## Origination Form Proposed Revisions to a Standard Plans Index

Originator:	Turley, Joshua	Index Number:	700-040
Date:	4/17/2024	Sheet Number(s):	2
E-mail:	Joshua.Turley@dot.state.fl.us	Index Title:	CANTILEVER SIGN STRUCTURE

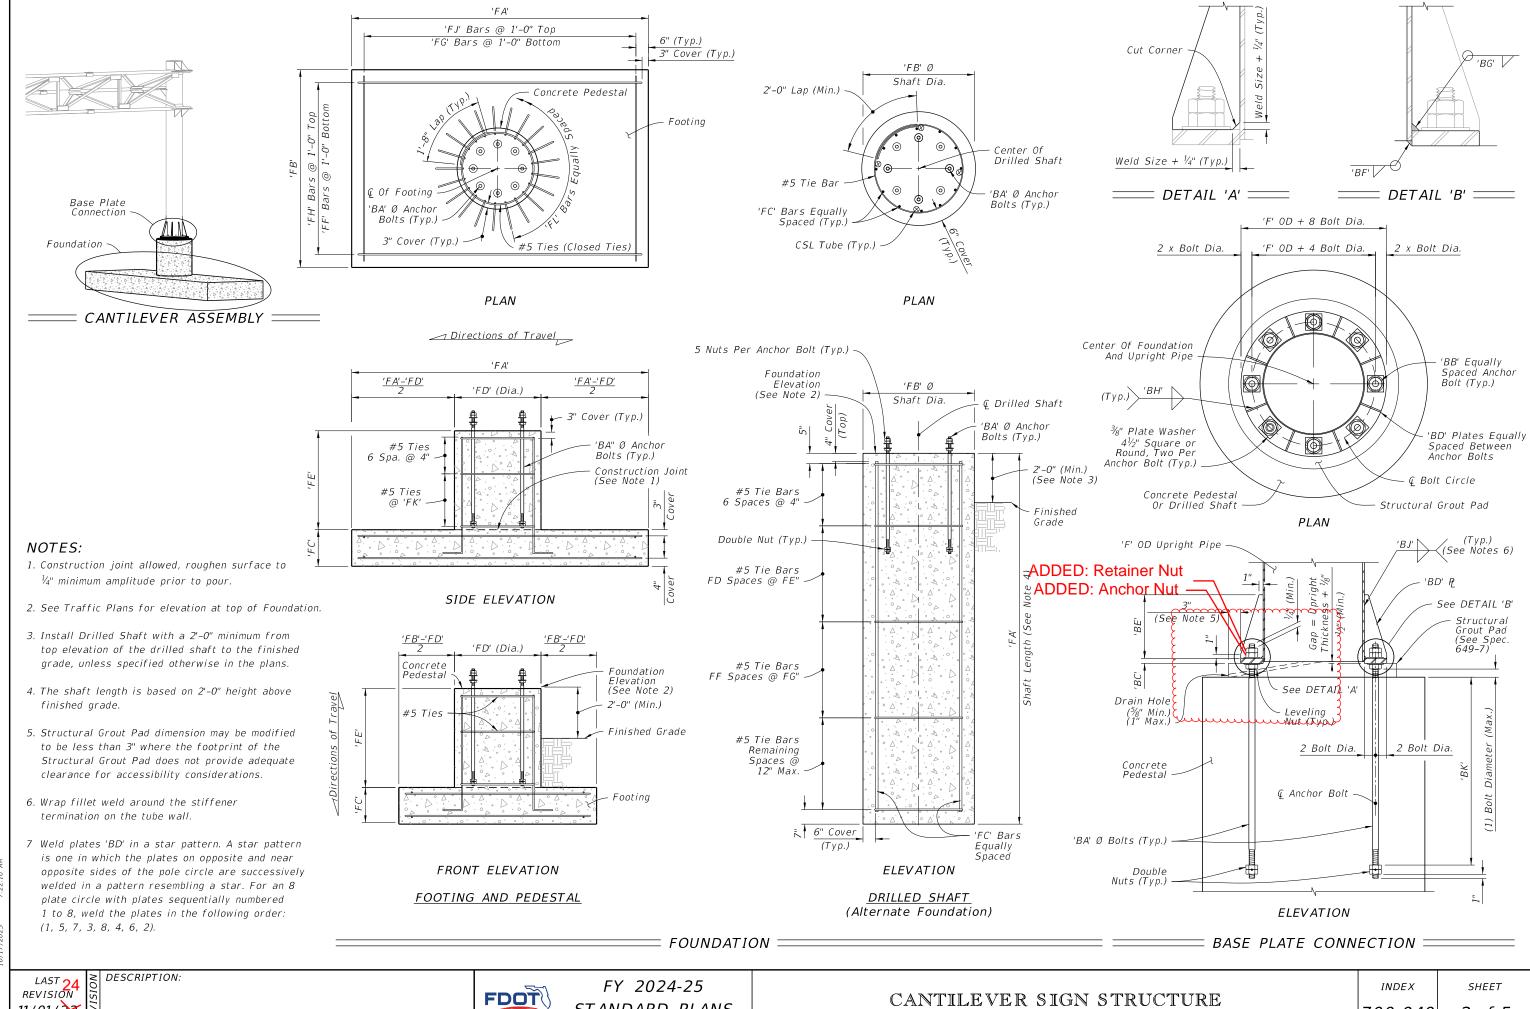
Sheet 2: Added anchor bolt nut labels in BASE PLATE CONNECTION

There is an associated Spec change being drafted for Section 649 that pertains to process for tightening the anchor bolts. These changes make it so that the language aligns between the Spec and the Standard.
